POUR/ZONE No. 1C6	FLOW DIAGRAM I-2-5114A
REQUIRED COMPLETION DATE	Q.S.I. SEE DESIGN
FABRICATED BY TUBECO	WELD PROCEDURE CODE STAMP
LIVSEY & COMPANY, INC. DONALD C. COOK NUCLEAR PLANT CONTAINMENT BLDG	
DATE: 7-28-71	DWG. NO.
DATE: 7-31-71	
ISSUED	I-NSW-G5 3
REF. DWG. 1-5489A	SM 1 OF 2

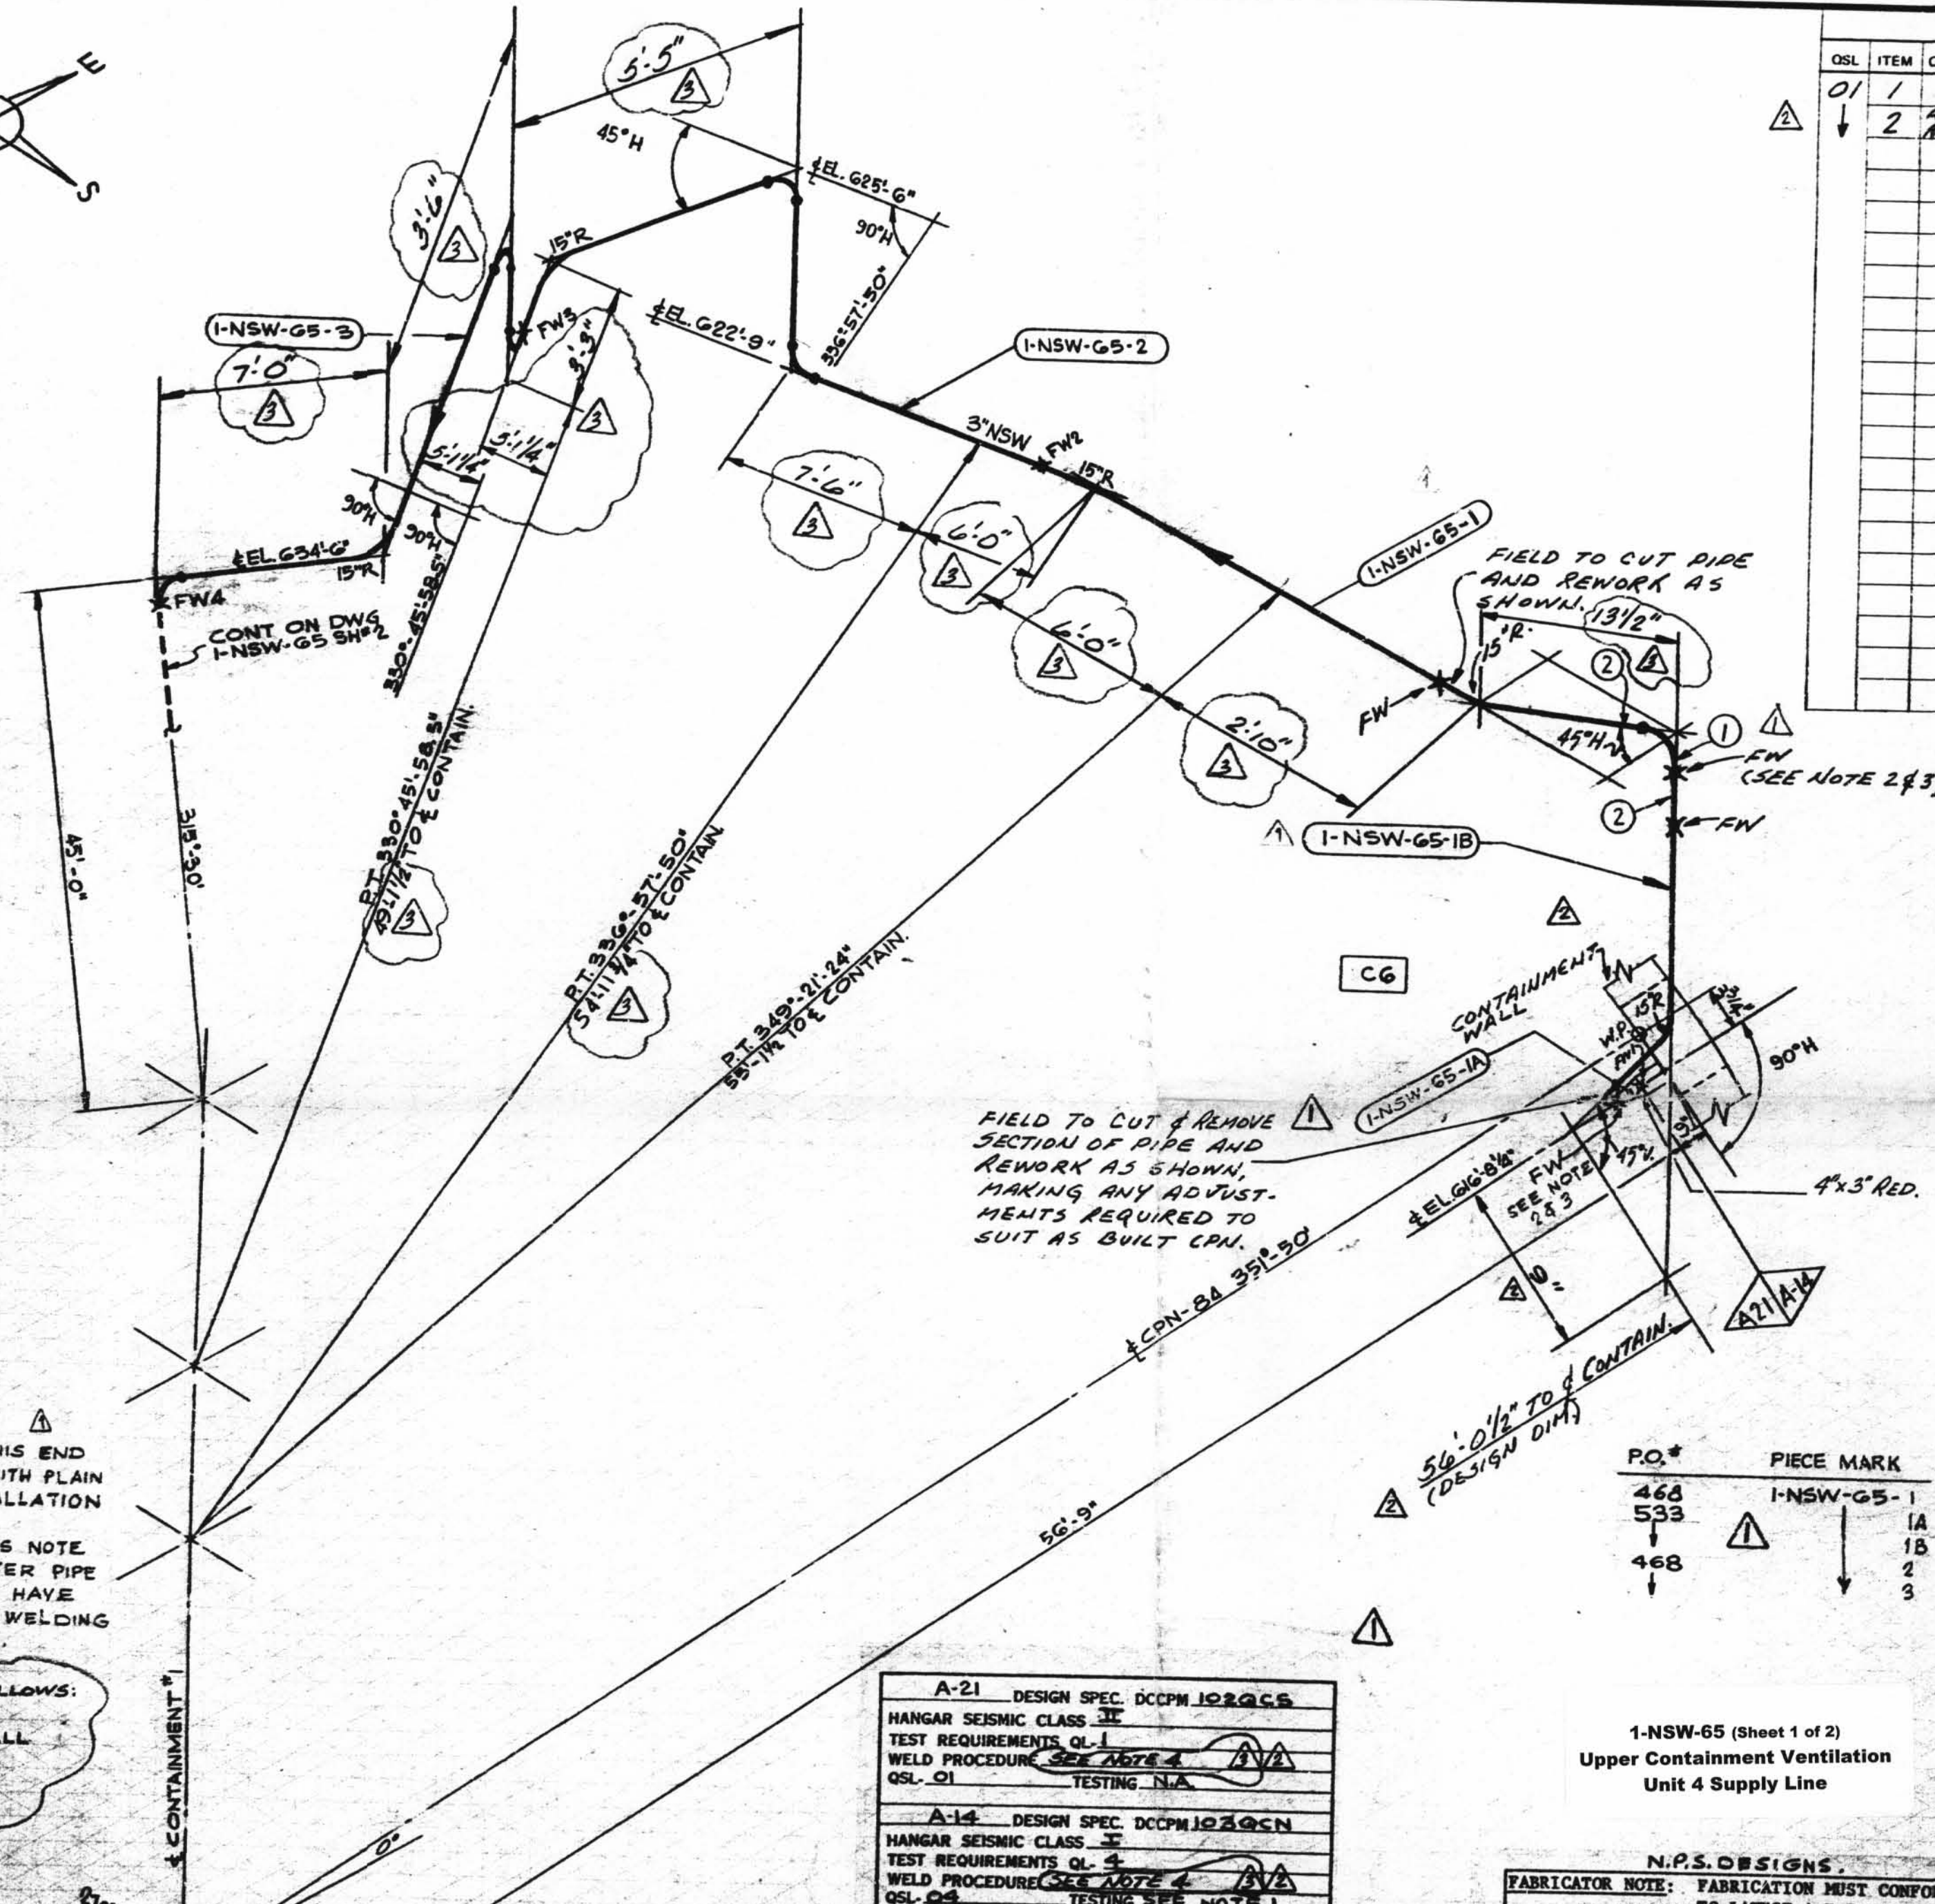
REV.	DATE	DR	CHK	DESCRIPTION	REMARKS
1	11/30/71	SG	GN	RELEASED PIPING AT CPN, ADDED: FWIAA 4 IBB, FC MK IA IB, PO. 07 DESIGN CODE STAMP, NOTES 2 & 3, TOTAL NO. OF FW, REVISED WELD PROCEDURE. PER DWG. 1-5489A	FIELD ACTION REQ'D FAB ACTION REQ'D
2	1/3/73	RS	LGR	ADDED: ITEMS 1 & 2 IN DIM. FIELD DIM. 5'-0" DIA. REVISED: 1-NSW-G5-1A DIM. 3'-6" 1-NSW-G5-1A DELETED WELD PROCEDURE PER DWG. 1-5489A REV. 3	FIELD ACTION REQ'D
3	2/11/75	GR	175	REVISED BY N.P.S. DESIGNS. ADDED: NOTE #4 DIM. 7'-0" 3'-6" 5'-11/2" 3'-8" 5'-5" 6'-0" 2'-10" 13'-1/2" DIM. 49'-11/2" WAS 49'-0" 54'-11/2" WAS 54'-0" 55'-11/2" 5'-11/2" WAS 5'-03/4" 1'-6" WAS 1'-0" PER AS BUILT DIMS. A.E.P. DWG. NO. 1-5489A	No ACTION REQ'D
